FW: A006653092 - COMPLIANT -174 Dowding st, oxley

**From:** -  
**Sent:** Tuesday, 9 June 2026 5:50 PM  
**To:** Kellie Hilton <Kellie.Hilton@brisbane.qld.gov.au>  
**Subject:** A006653092 - COMPLIANT -174 Dowding st, oxley

I am writing to formally lodge a complaint regarding the current Development Application (DA) submitted to BCC for the subdivision.

CONCEPT PRE STORMWATER CATCHMENT LAYOUT PLAN

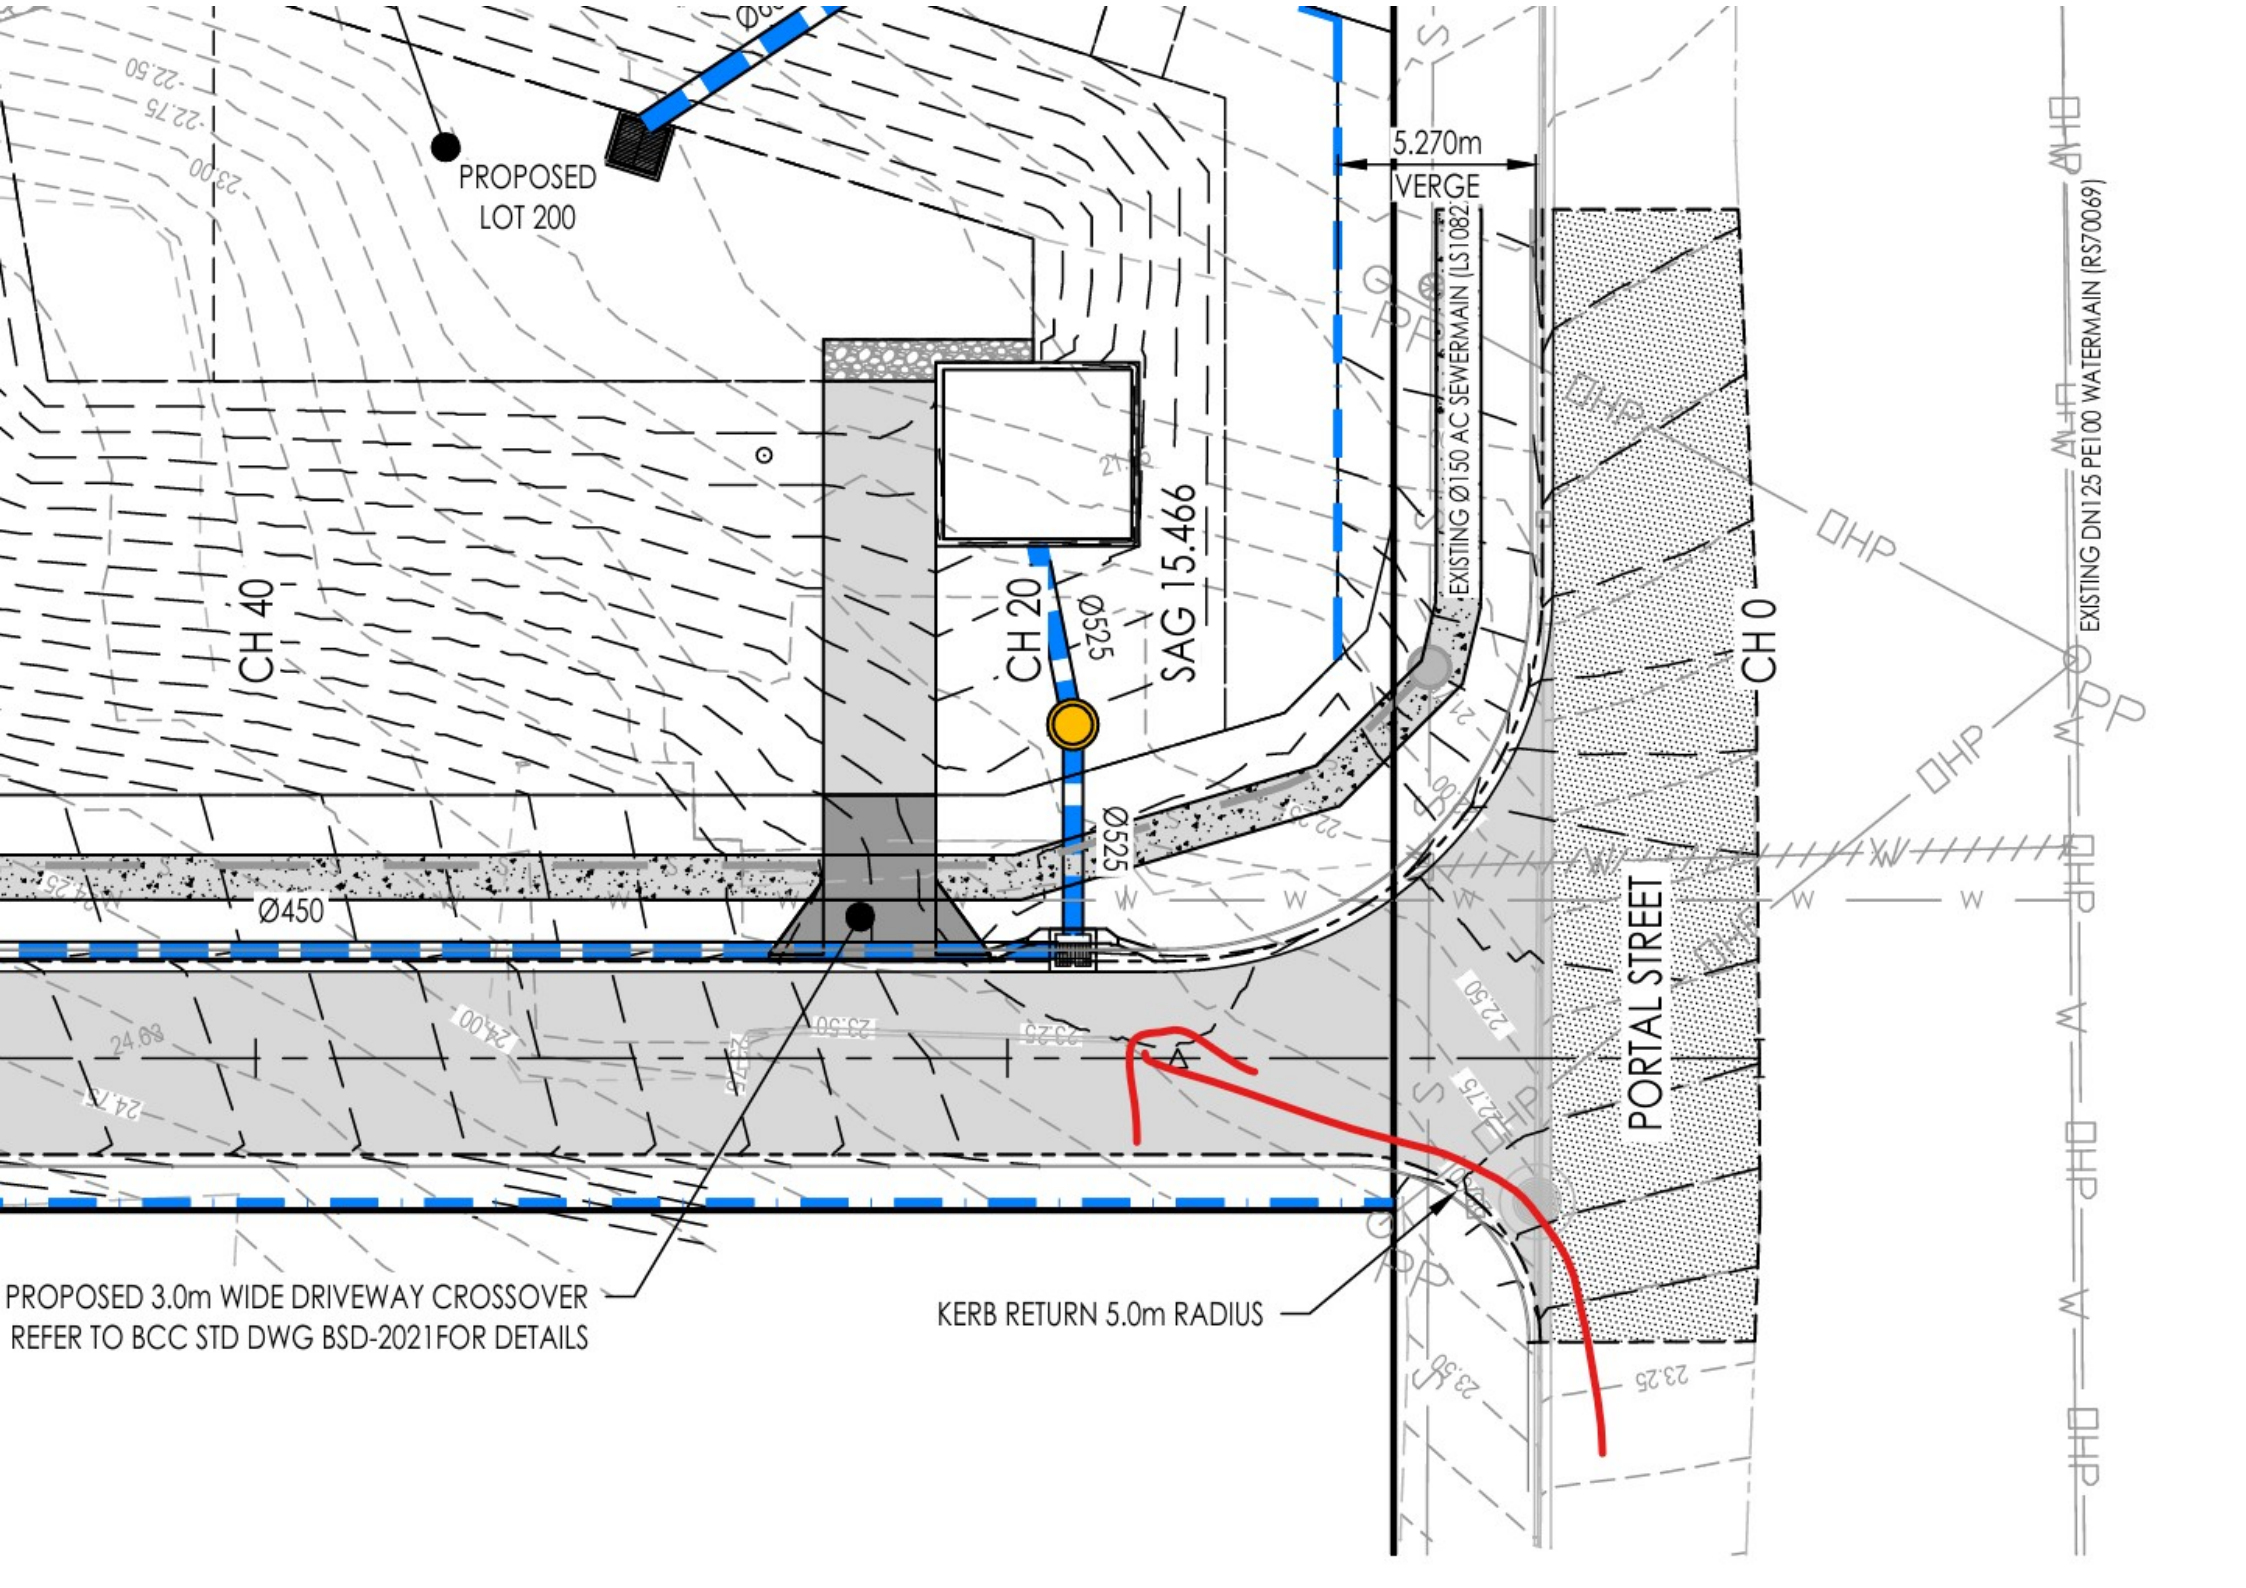
The primary concern relates to the proposed bio-retention basin, which appears to have been designed without adequate consideration of the existing upstream catchment impacts. Specifically, the application fails to sufficiently address the following:

- Stormwater Quantity: The potential for increased runoff volumes from the upstream catchment and the resulting impact on the basin's capacity, as per the DRAINS model.
- Stormwater Quality: The cumulative pollutant loads from the upstream area and whether the proposed measures can effectively manage these inputs to protect the local environment in the MUSIC Model.

It is essential that these upstream factors are fully integrated into the assessment to ensure the long-term functionality and compliance of the stormwater management system. I request that these technical oversights be reviewed and addressed before the application proceeds further as part of the current RFI or subsequent RFI.
